STATEMENT OF RESPONSE TO PRE-APPLICATION CONSULTATION OPINION

BUILD-TO-RENT RESIDENTIAL AND COMMERCIAL DEVELOPMENT
FORMER CHADWICKS SITE, GREENHILLS ROAD,
WALKSINTOWN, DUBLIN 12

MARCH 2022

Figure 2.0 Extract from the Landscape Plan Design Statement showing the public open space, communal open space and public realm

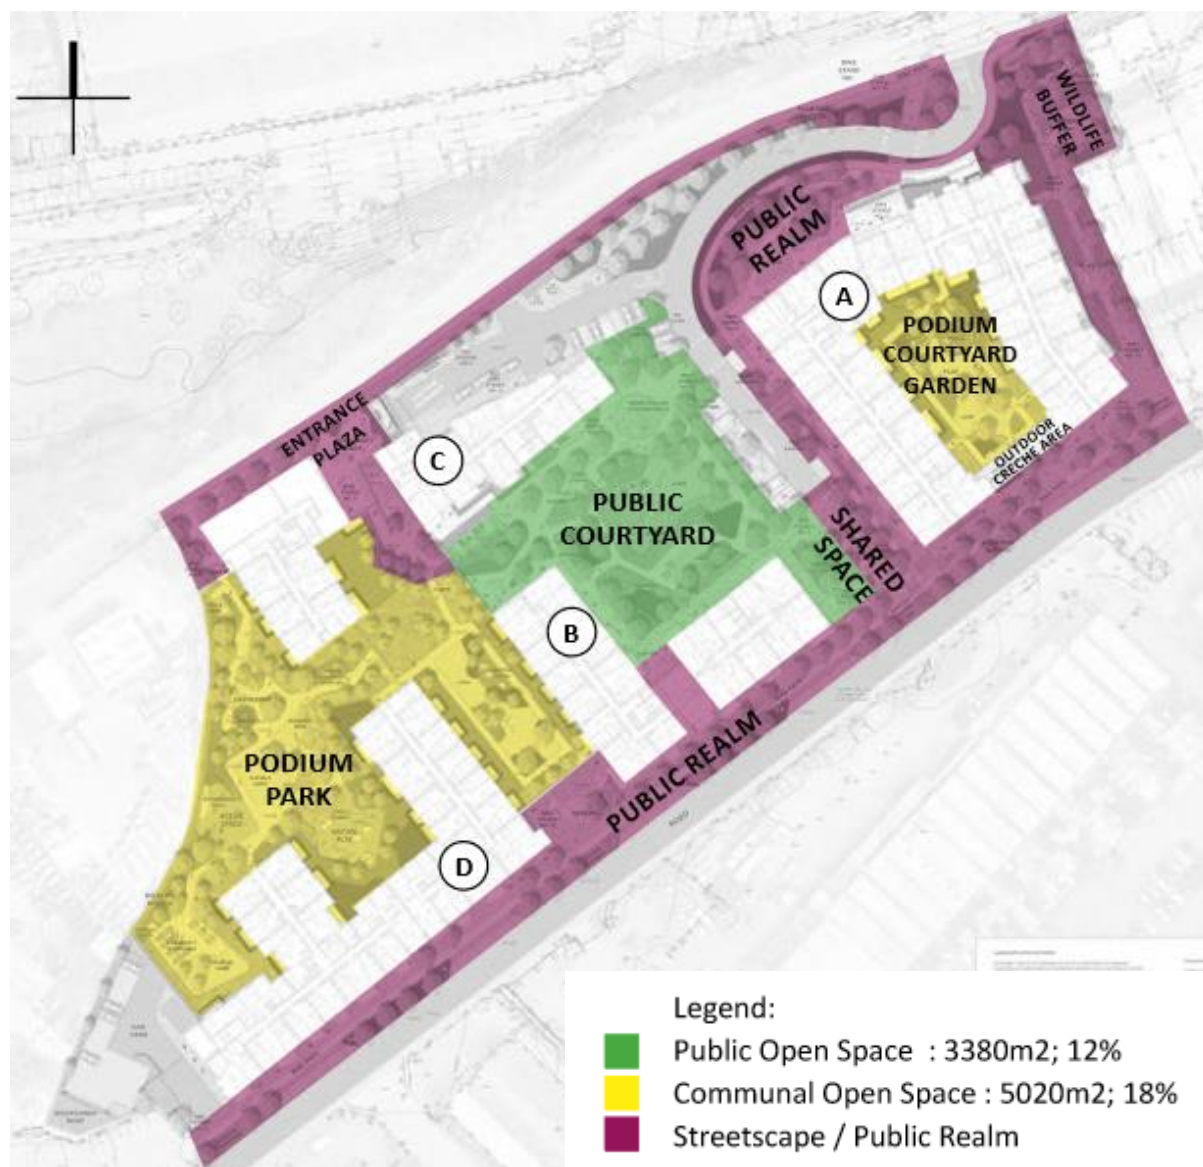
3.4 Provision of Landscape plan clearly delineating communal and private spaces. Requiring consideration of how the design of the landscape and provision of furniture/equipment will facilitate use of these spaces for both adults and children and security of access to communal amenity space.

A Landscape Plan and Design Statement have been prepared by Park Hood Landscape Architects and included with this application. The landscape design aims to create a sense of connectivity between spaces and promotes a sense of place and well-being within the development. This will be achieved through the use of high-quality materials and the establishment of a carefully considered planting scheme.

A coherent pedestrian footpath network ensures residents and guests can navigate around the site easily. This aims to encourage residents to interact and use the public open space created within the landscape design. The main public open space incorporates play spaces to ensure the landscape is interactive for children of all ages. Communal open space is provided at podium level and includes areas of hard landscape, tree planting, lawns, ornamental planting including seating / passive amenity areas, and areas for communal garden and outdoor working.

Figure 4.0 Masterplan for the area as prepared by C+W O'Brien Architects

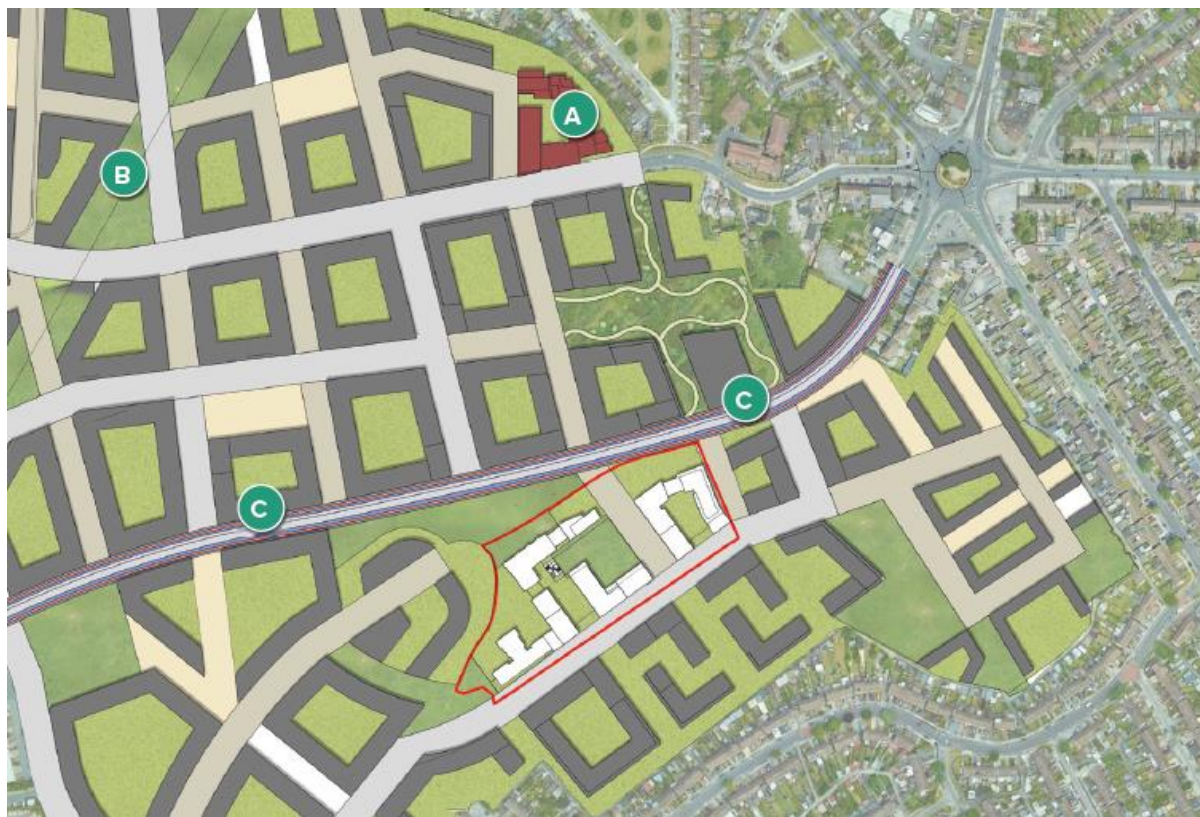
- Masterplan required to ensure development fits in with future development
 - Location of access road from Greenhills Road should be cognisant of Bus Connects proposals for the area

It is important to note that the City Edge Project is in its early stages and no master plan for the areas has been prepared. In the absence of a master plan, C+W O'Brien Architects has prepared a master

plan concept to see how this development would fit into the area whilst accommodating other developments in the area. A 3-dimensional model of the masterplan has also been prepared and included with this application.
